Genesis Solar Energy Project - Docket Number 09-AFC-8

Genesis Solar Energy Project

09-AFC-8

Data Adequacy Supplement 1A- Drainage Design Narrative/Work Plan

**MAP OF PRE-PROJECT
100 YEAR FLOW PATTERN**

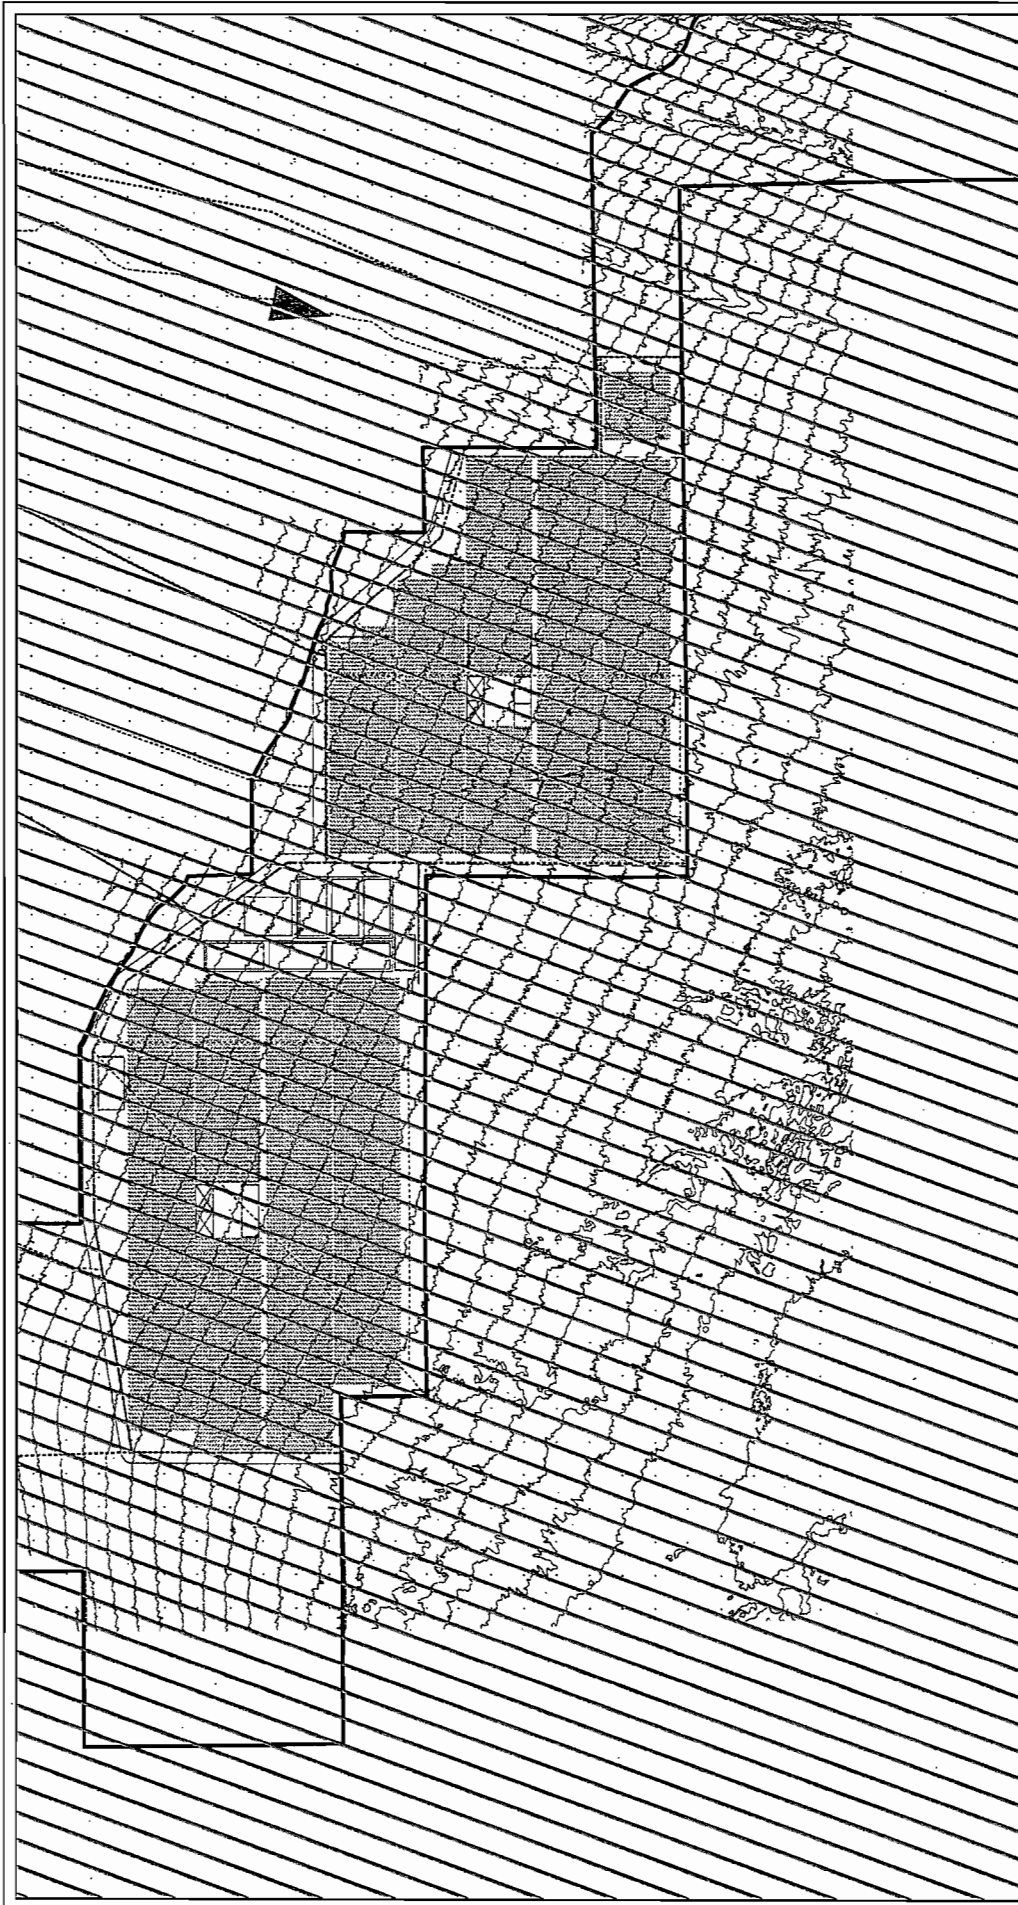
The Applicant needs to provide a preliminary design of the project drainage plan. The Applicant must supply pre-and post-development 100-year floodplains for the following reasons:

1. To assess what impacts will occur from the proposed development;
2. To assist in the determination of jurisdictional waters of the State of California;
3. For the development of the Streambed Alteration Agreement (the SAA permit is typically issued at the same time the permit for the project is issued).

The design of open channels requires that it be known where flow will be collected and conveyed, and where flow will only be conveyed. There is a significant difference between the design of a collector channel and a conveyance channel. If the limits of potential inflow to the channel are not known, then all reaches where there appears to be the possibility for concentrated lateral inflows should be designed as a collector channel to minimize the possibility of erosion and headcutting.

It should be noted that the absence of FEMA mapping for an area does not indicate that significant floodplains or flood-related hazards do not exist.

In addition, the Applicant did not provide any alternatives to the proposed drainage plans for the Site. The determination of pre-and post-development 100-year floodplains with various alternatives would be required as part of the data adequacy requirement.

There are no FEMA defined floodplains or floodways entering the up-gradient portion of the Site. The up-gradient flows enter the project as numerous small braided channels and sheet flow (see attached Figure 1, Map of Pre-Project 100 year Flow Paths). The flow in each channel and across the north portion of the Site is dependent upon the amount of precipitation, the drainage area upstream, and duration of precipitation. Based on the *Survey for Jurisdictional Waters and Wetlands at the Genesis Solar Energy Project, Eastern Riverside County, California* provided in Appendix C-1 of the AFC, there are 29 identified channels, two of which may be considered waters of the State. However, these determinations are not final. Only a few of the conveyance channels are located within the facility footprint itself; most are channels that will intersect with the linear corridor. The linear corridor and associated access road will be designed using low, flat culverts to facilitate normal flows beneath the access road.

**MAP OF POST-PROJECT
100 YEAR FLOW PATTERN**

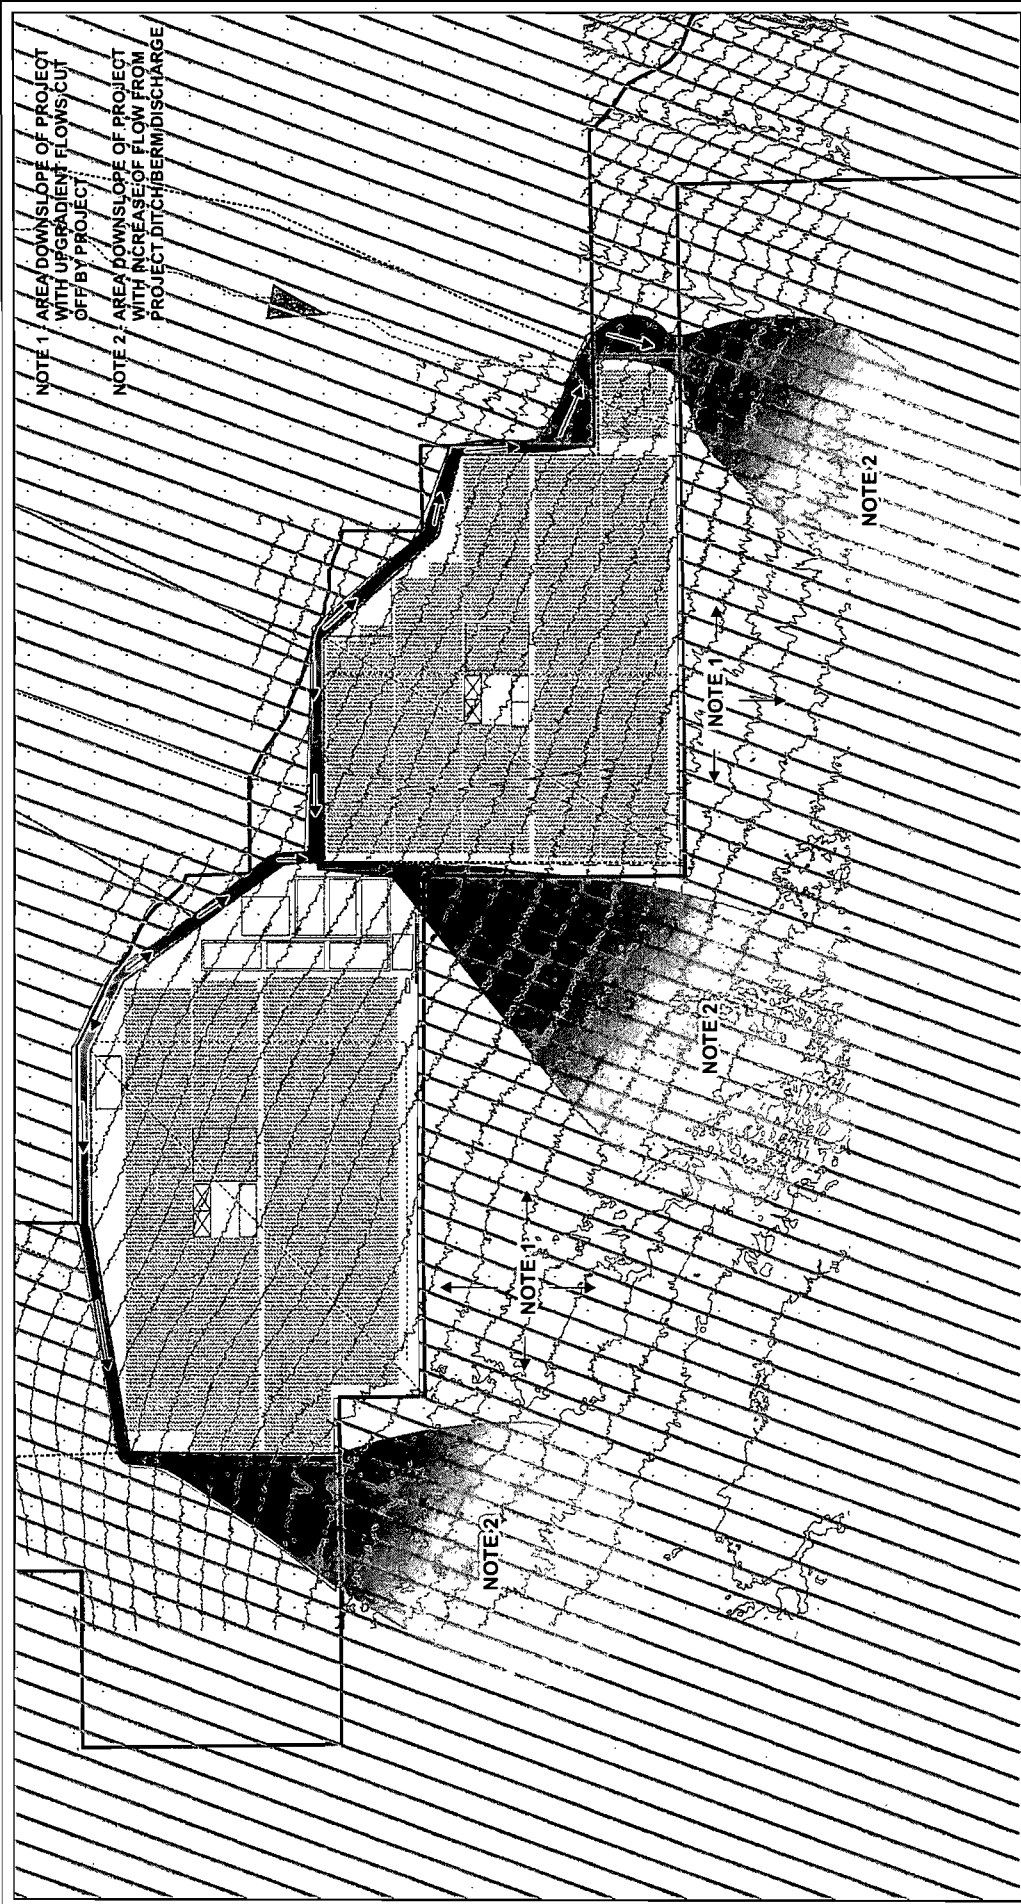
The effects of the project on the 100-year flood plain, flooding potential of adjacent lands or water bodies, or other water inundation zones.

As the up-gradient 100 year storm flows enter the Site, the flows will be intercepted by ditches and berms. These ditches and berms will be used to divert the 100-year storm flow around and through the Site. The flows within the ditches and behind the berms will increase in volume (width and depth) as they are captured. As the flows pass through and around the Site they will be concentrated into three major flows and discharged to the south. These anticipated flow patterns can be seen in Figure 2, Map of Post Project 100 year Flow Paths. The flows will be discharged as shallow flat sheet flow. Because the up-gradient flow from the numerous channels and sheet flow will be captured across an area approximately 19,000 feet in width, and discharged at the southern edge of the project across an area of less than 3,000 feet in width, it is expected that the flows will be more concentrated leaving the Site at the three ditch/berm outfall locations. At these locations, engineering means will be used to minimize erosion and

disperse the flows as quickly as possible back to sheet flow conditions. The areas anticipated to be impacted by this are shown in Figure 2, Map of Post-Project 100 year flow paths.

These ditches and berms will be engineered structures, and may be lined with rip rap or other engineered materials to protect the integrity of the earthen banks and bottoms. These structures will be used to dissipate the water as quickly as possible back to downstream sheet flow conditions to mitigate impact on biological habitats.

NOTE 1 AREA DOWNSLOPE OF PROJECT WITH UPGRADIENT FLOWS CUT OFF BY PROJECT

NOTE 2 AREA DOWNSLOPE OF PROJECT WITH INCREASE OF FLOW FROM PROJECT DITCH/BERM/DISCHARGE
